# UNITED STATES PATENT AND TRADEMARK OFFICE

APPLICATION NO.	FILING DATE	FIRST NAMED INVENTOR	ATTORNEY DOCKET NO.	CONFIRMATION NO.
10/595,556	04/27/2006	Thomas Nissl	NISSL	2770

## Office Action Summary

**DETAILED ACTION**

**Fig 11:**

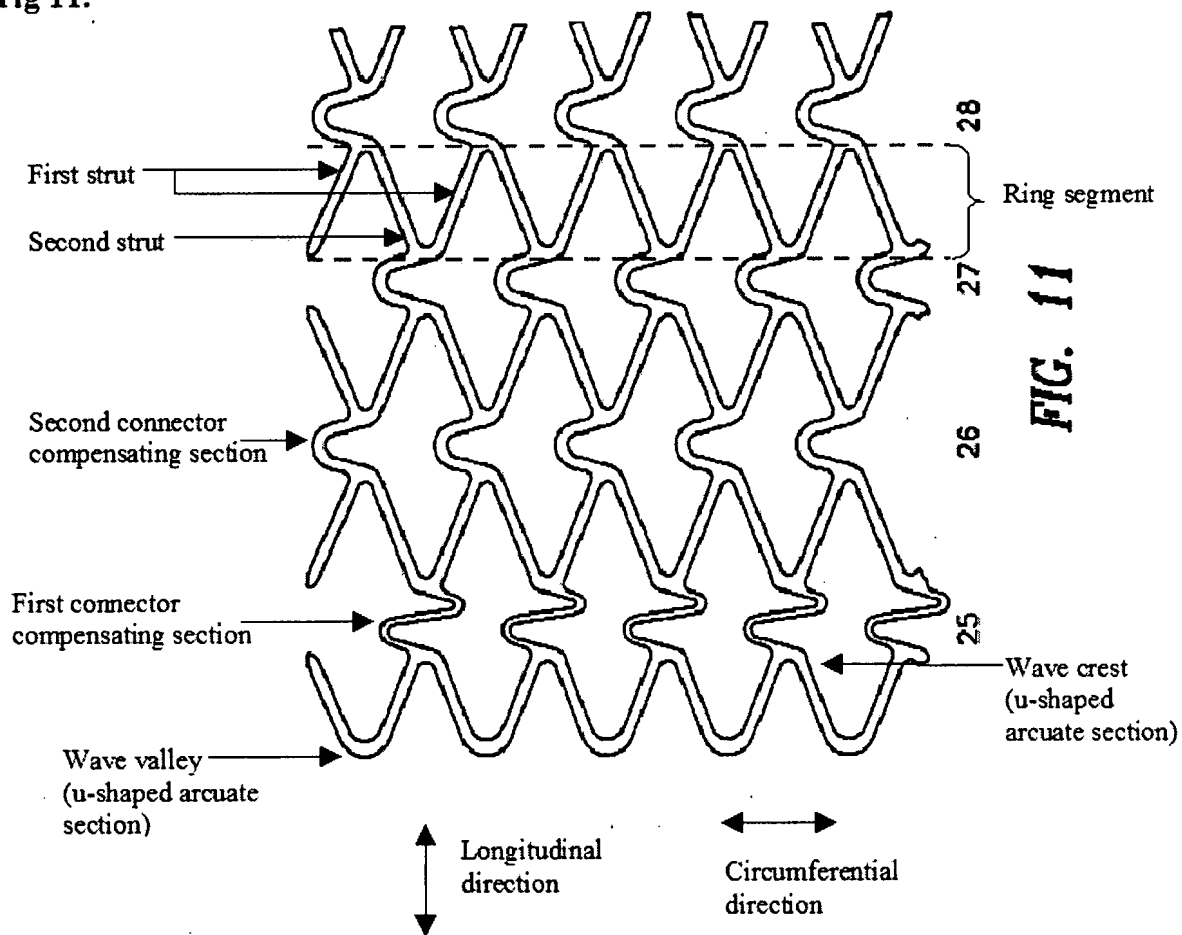
3. The text of those sections of Title 35, U.S. Code not included in this action can be found in a prior Office action.
4. Claims 6, 2, and 4 are rejected under 35 U.S.C. 102(b) as being anticipated by Richter (US 5,807,404). Regarding claim 6, Richter discloses an expandable stent comprising a tubular support frame defining a longitudinal axis (Fig 4) and including a plurality of ring segments (col 2, lines 52-57), as shown below in Fig 11, arranged in succession in a direction of the longitudinal axis and formed by struts which are joined continuously in a wavelike manner in a circumferential direction of the support frame. The struts are curved arcuately and merge together to form U-shaped arcuate sections. First and second connectors link adjacent ring segments. The connectors alternate in the circumferential direction and in the direction of the longitudinal axis and are formed with a U-shaped compensating sections pointed in the same circumferential direction. The first connectors are longer in length than the second connectors and curved in the same circumferential direction as the struts (see Fig 11 below).

Regarding claim 2, Richter discloses the ring segments define wave crests and wave valleys, which confront one another (see Fig 11 below).

Regarding claim 4, Richter discloses the connectors arranged successively in the longitudinal axis are linked to the U-shaped arcuate sections of the struts by connections, where the first and second connections confront one another (see Fig 11 below).

6. Applicant argues Richter discloses struts that have a straight configuration. The Examiner respectfully traverses the Applicant's remarks. Richter discloses the struts merge into one another via U-shaped arcuate sections, as seen in Fig 11 above. Thus, the struts are slightly curved at the U-shaped section where the first and second struts are joined.

8. Applicant argues Richter discloses the legs of the connectors are straight. The Examiner respectfully traverses the Applicant's remarks. Richter discloses the legs of the connectors merge into one another via U-shaped compensating sections, as seen in Fig 11. Thus, the legs are slightly curved at the U-shaped section where the first and second legs are joined.

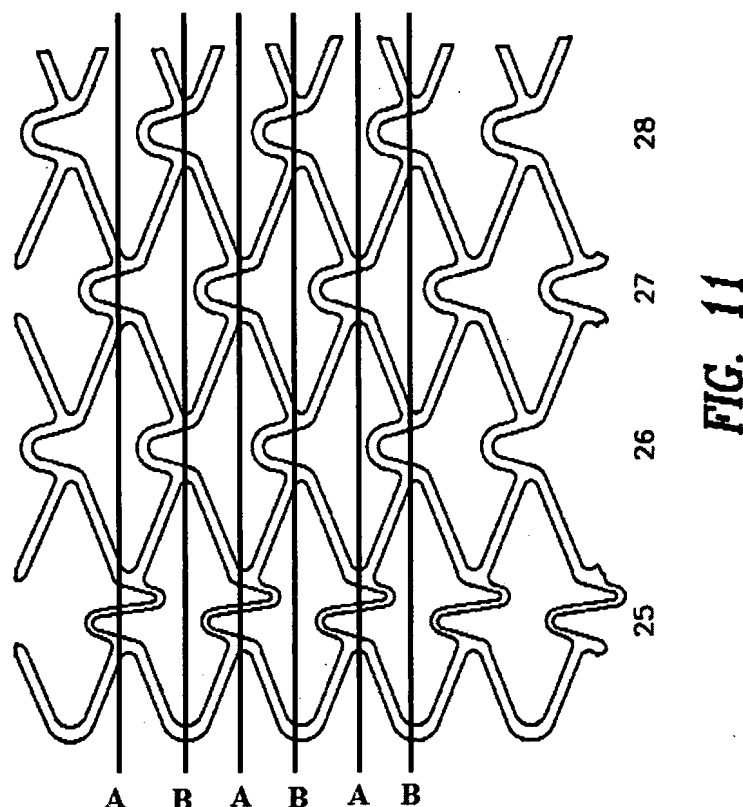
Regarding the arrangement of the connectors, it is clear from Fig 11 above that the first and second connectors alternate in the longitudinal direction since the first connectors are found in the bottom row and the second connectors are found in the

next row up from the bottom. Furthermore, the connectors alternate circumferentially as shown below in a second marked up view of Fig 11:

In the above figure, A represents the first circumferential point and B represents a second circumferential point. Focusing on the bottom two rows, the connector at point A is the first connector while the connector at point B is the second connector, which continues to alternate at successive circumferential positions.
